Department of Environmental Quality

Re: WQ: CAS: Variance Denial: 248-23-000443-VAR: 16992 Downey Rd; T.20; R.10; Sec. 12B; Tax Lot 6000; 0.57 Acres; Deschutes County.

Variance Decision:

Revised Plot Plan Layout 5/13/24 gsk

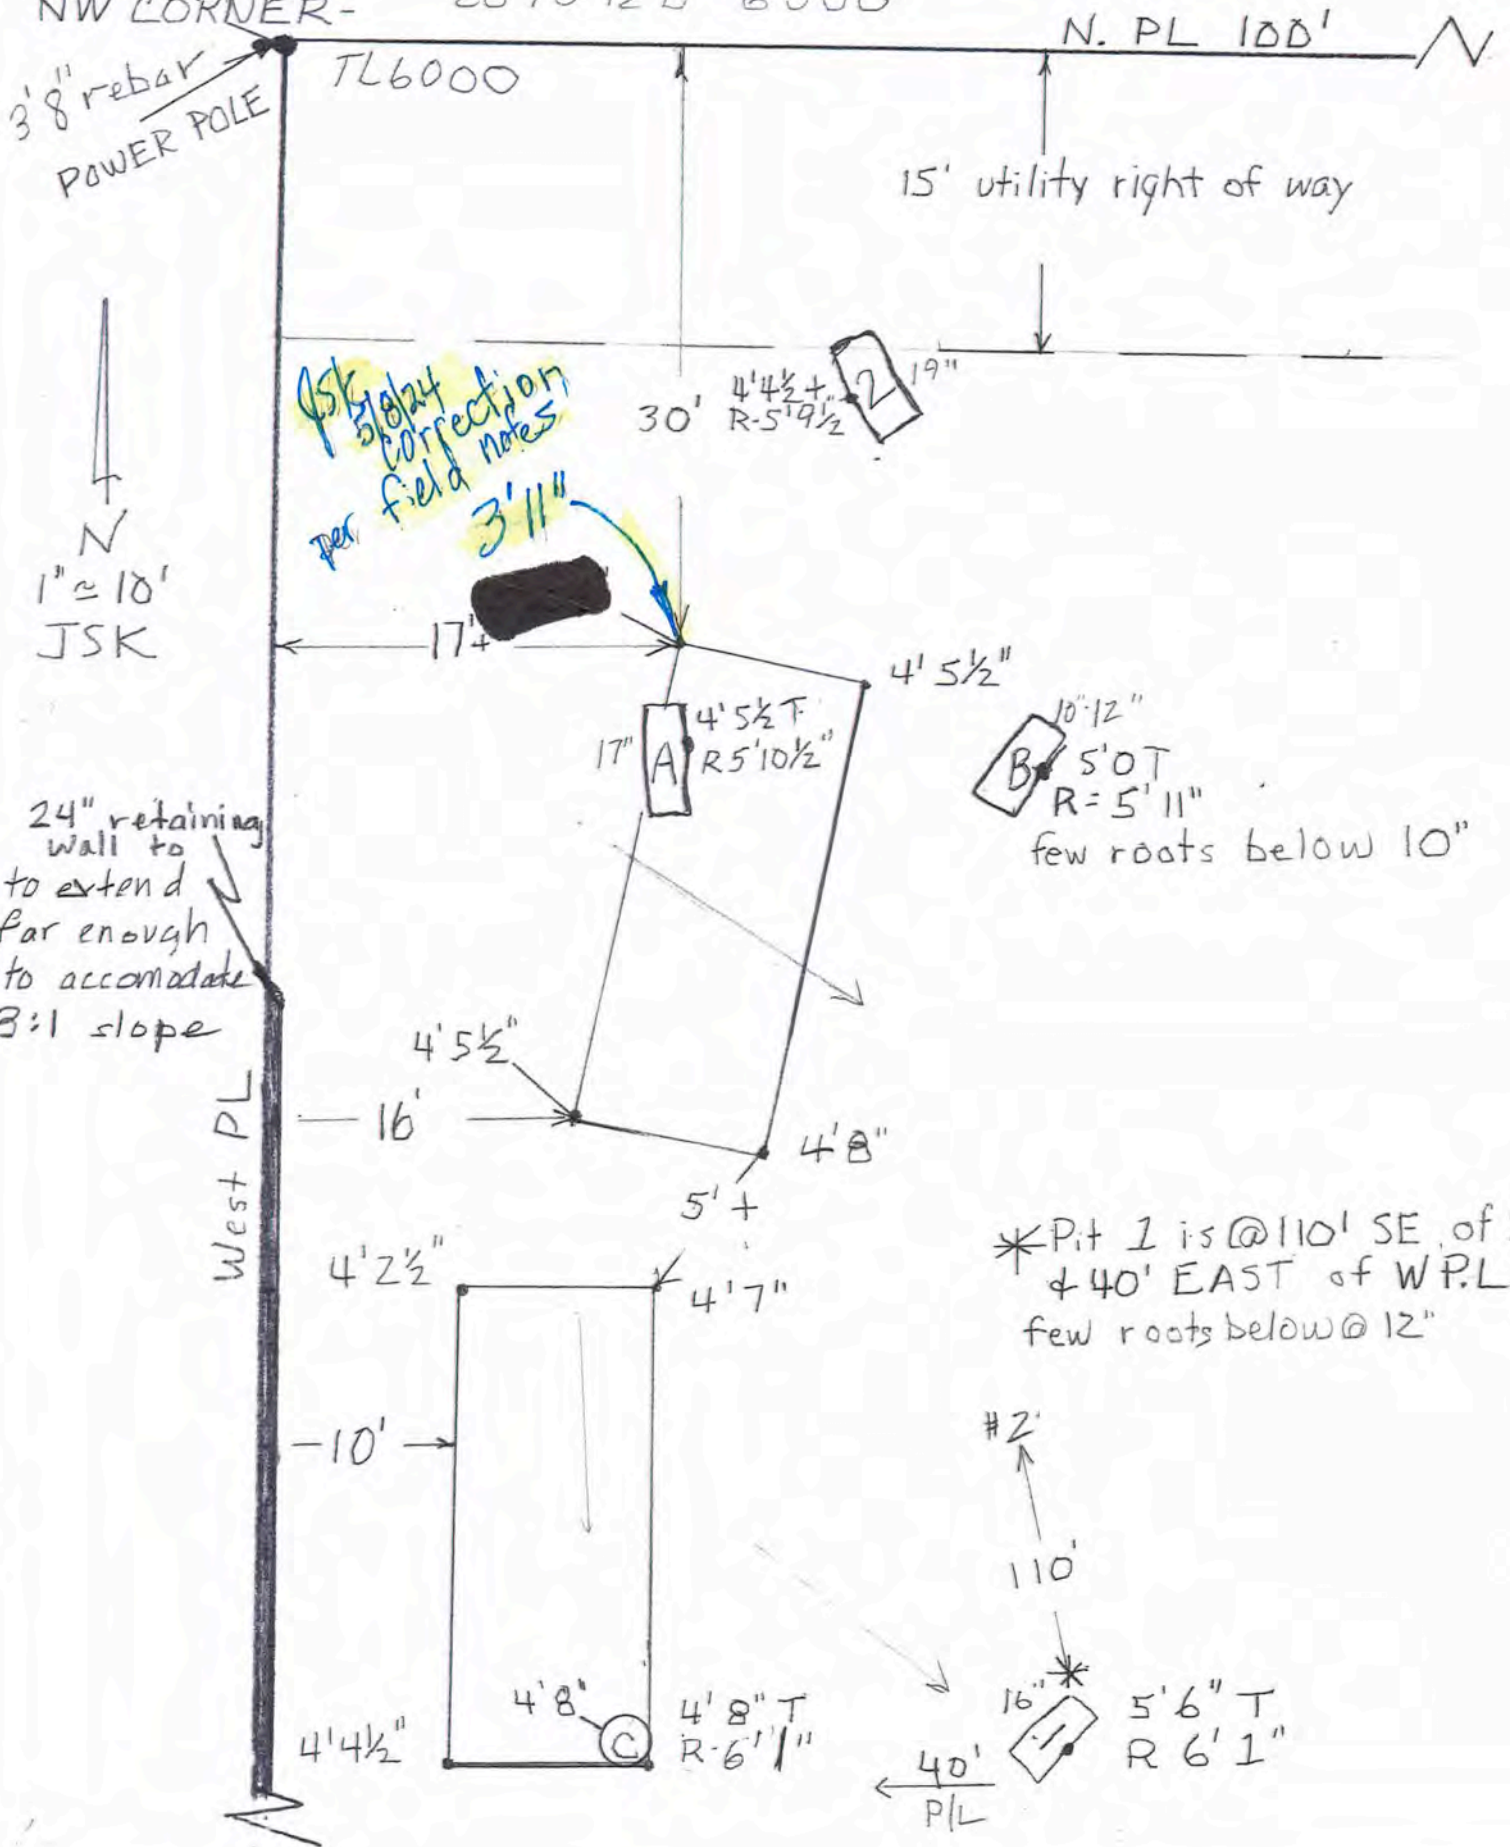
A site visit was made by the variance officer on April 23, 2024 to observe the site and proposed system layout. The stake-out of the bottomless sand filter locations appeared to match the proposal site plan and were located near the existing test pits 1&2 from the site evaluation conducted by Deschutes County. Gray / depleted soil colors were observed near the ground surface in both pits, indicating that the depth of seasonal high saturation could be higher than the assumed depths used for the proposed system.
